**MOORPARK CITY COUNCIL
AGENDA REPORT**

SUBJECT: Consider Additional Funding for Electrical Additions and Revisions and Amendment No. 7 to the Agreement with Taft Electric Company for the Ruben Castro Human Services Center

**SEVENTH AMENDMENT TO AGREEMENT 2011-072
FOR BID PACKAGE #16 – ELECTRICAL
AT THE RUBEN CASTRO HUMAN SERVICES CENTER**

A 5.2

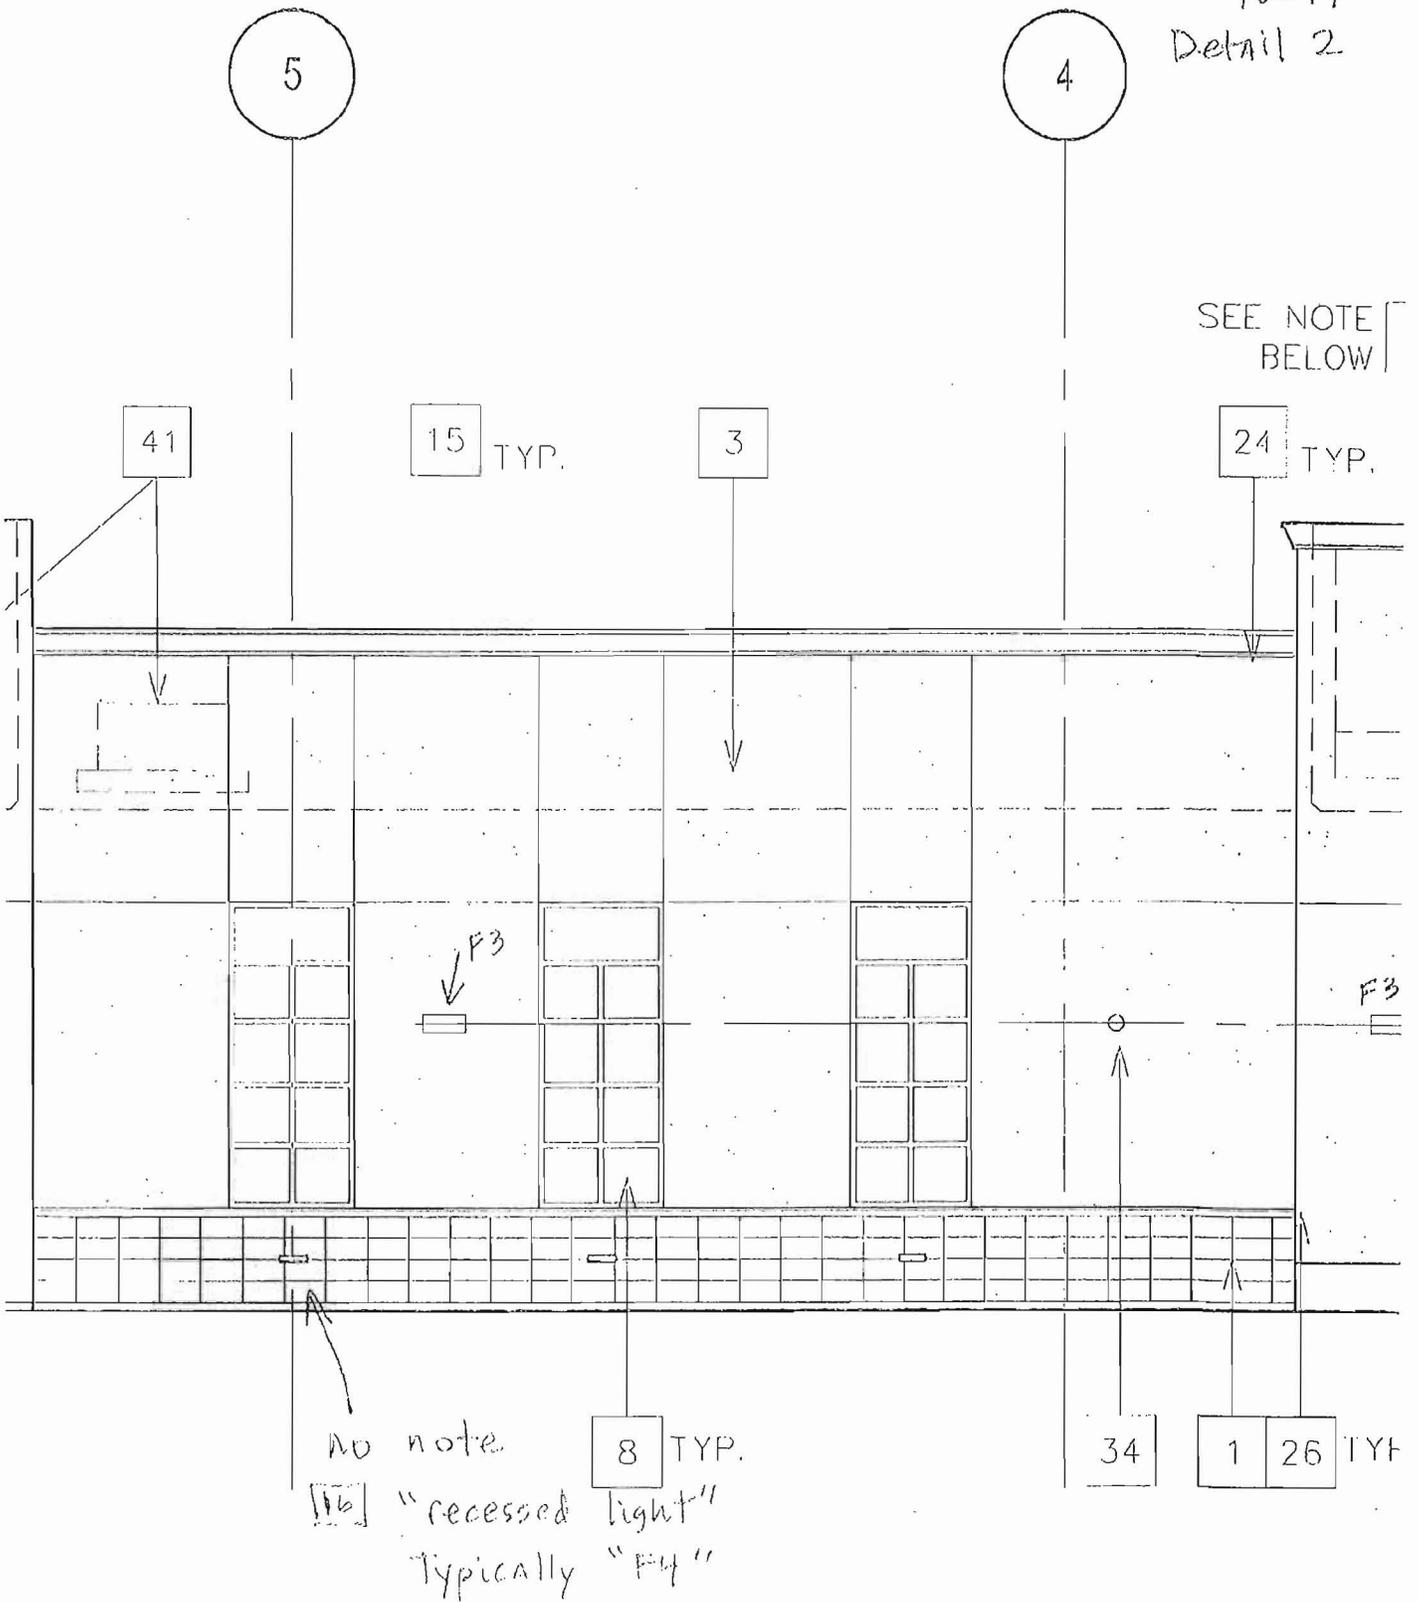
Attached are drawings E1.0 and A5.2. Drawing A5.2 shows 3 - F4 fixtures in the veneer but there is no note 16 indicating that these are step lights. Drawing E1.0 does not show these fixtures at all.

Please advise if these are to be added to our scope.

Yes, F4 fixture located in the veneer can be interconnected to the same circuit serving the F3 fixtures above.

Confirmed, per your sketch 2/A5.2. Design intent shown on 2/A5.2, (1) F3 light fixture between windows and (3) F4 step lights. Step lights per your submittal #013-16510, light fixture F4.

Drawing No
RFI-0250

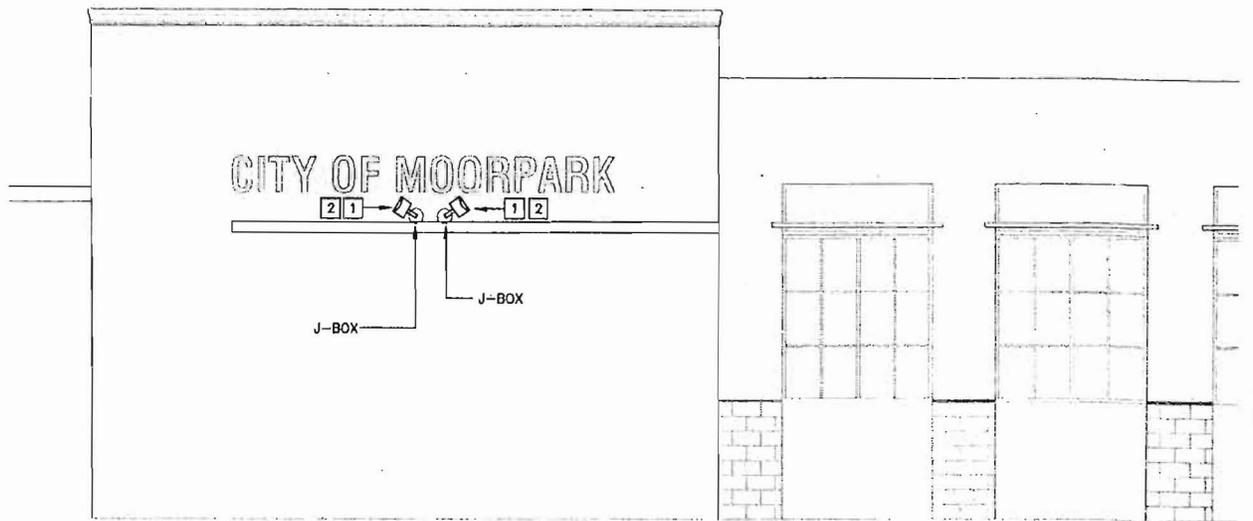
Please provide information and a location for the power that is needed for the signage on the west side of Bldg A.
See attached drawings.

See sketch #1 for the information related to signage for Bldg A.

- 1 ALLSCAPE SIGN ACCENT LIGHTING FIXTURE WITH (2) 32-WATTS FOR EACH LUMINAIRE. MODEL #: ALLSCAPE FL-12 K (2)32CF-120V-JBCP1
- 2 PROVIDE JUNCTION BOX CYLINDRICAL 120V BUTTON PHOTOCELL CONTROL WITHIN THE FIXTURE. PROVIDE CONNECTION TO PANEL "AP1-1".

REFERENCE
 DRAWING NO. 84-28783
 REVISION: B

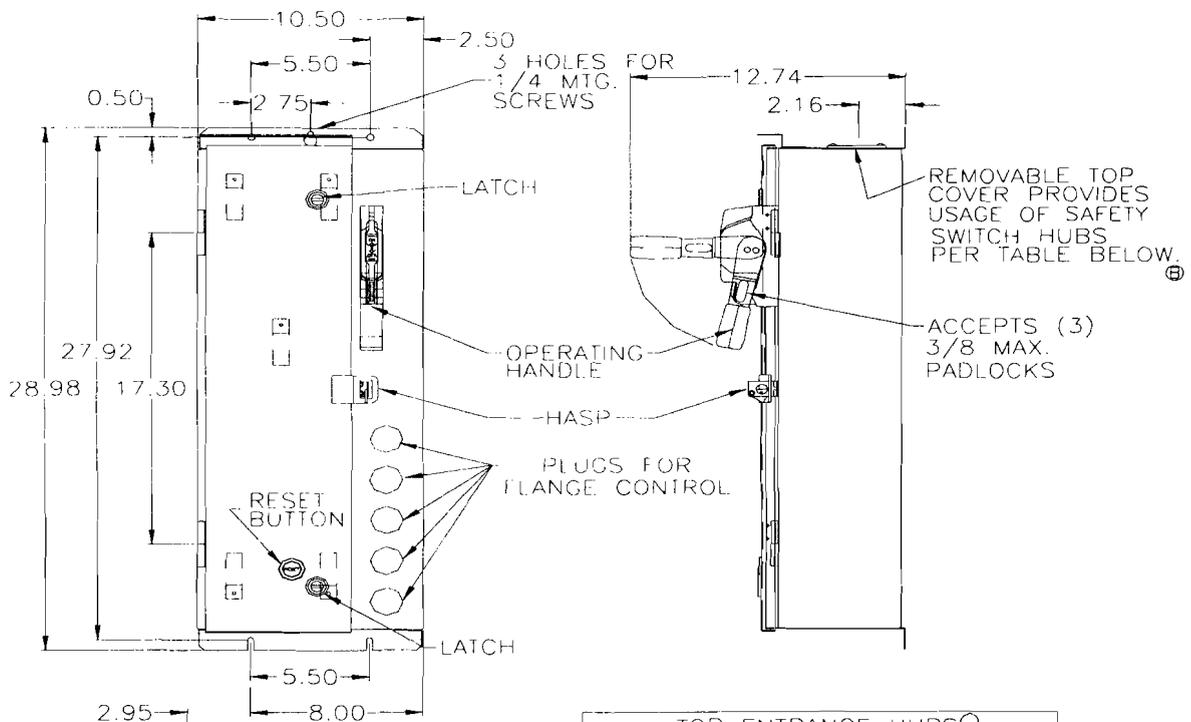
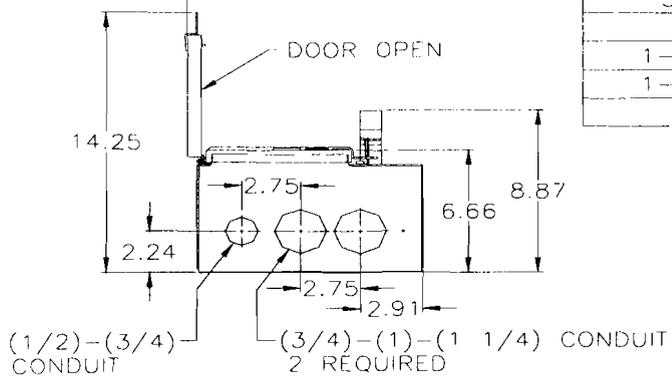
Balfour Beatty Construction has requested input from the installing contractors and they have declined to provide any information as to the what will fit the equipment. We would like to request the consulting engineer of record for the HVAC to provide sizes and specs that best match the approved equipment that the magnetic starters are matched too.

RFI 242 response indicated there was to be no VFD's required. The electrical plans indicate "DISCONNECTS" are to be provided. Please confirm if a "Mag Starter" is required so that these pumps do not run 24hrs - 7 days a week with just the disconnects as shown on electrical drawings.

1. All work to be done during normal working hours. No overtime or premium time is included.
2. Remove Disconnects already installed at Pumps 1-3 on roof of Building A.
3. Provide and Install 3 Combo Mag Starters per RFI 242 R2 Attachment.
4. Lead time for starters is 2 weeks from Approval and Release.
